Well Name: JULANDER FEDERAL	Well Location: T29N / R11W / SEC 31 / NESW / 36.679565 / -108.034866	County or Parish/State: SAN JUAN / NM
Well Number: 1E	Type of Well: CONVENTIONAL GAS WELL	Allottee or Tribe Name:
Lease Number: FEE	Unit or CA Name: JULANDER	Unit or CA Number: NMNM73585
US Well Number: 300452500000S1	Operator: LOGOS OPERATING LLC

Procedure Description: Bradenhead Remediation - Please see attached 3rd proposed repair procedure and wellbore

Julander 1E NOI for Bradenhead Remediation

Action 426342

Well Schematic

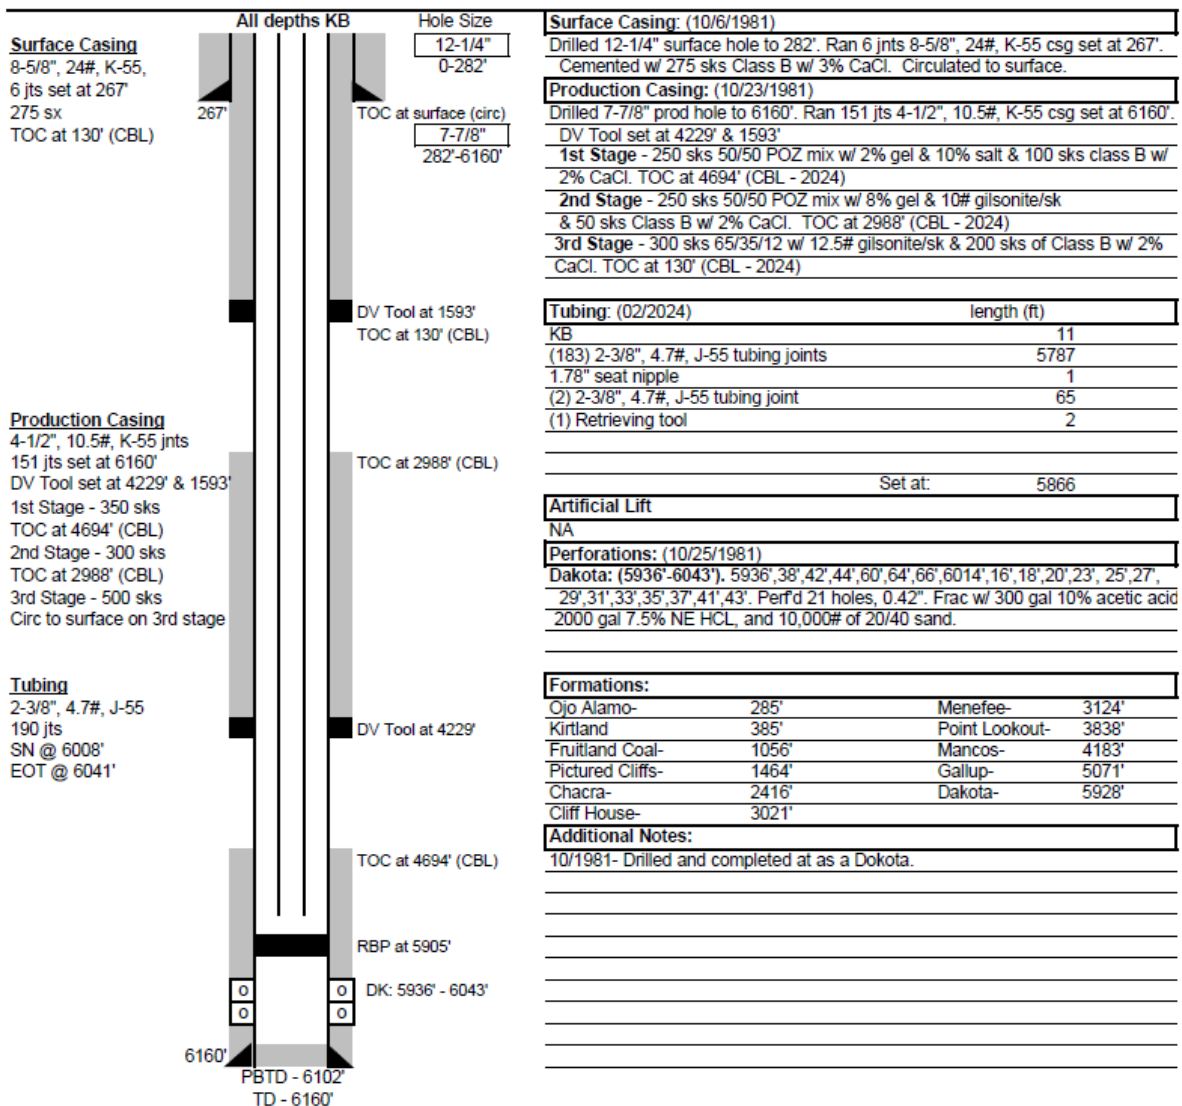
Created By	Condition	Condition Date
ward.rikala	OCD requires a pre LET job and post LET job caliper log from the DV tool to surface.	2/3/2025
ward.rikala	OCD requires a pre LET and post LET CBL from DV tool to surface.	2/3/2025
ward.rikala	The depths authorized for use are 1480', 1473', 1418', 1378', 1370', 1360', 1044', and 1011'.	2/3/2025
ward.rikala	Perform MIT in 30 days and another 1 year from date of workover.	2/3/2025
ward.rikala	Perform Bradenhead test in 30 days, another in 6 months, another in one year and then annually after that.	2/3/2025
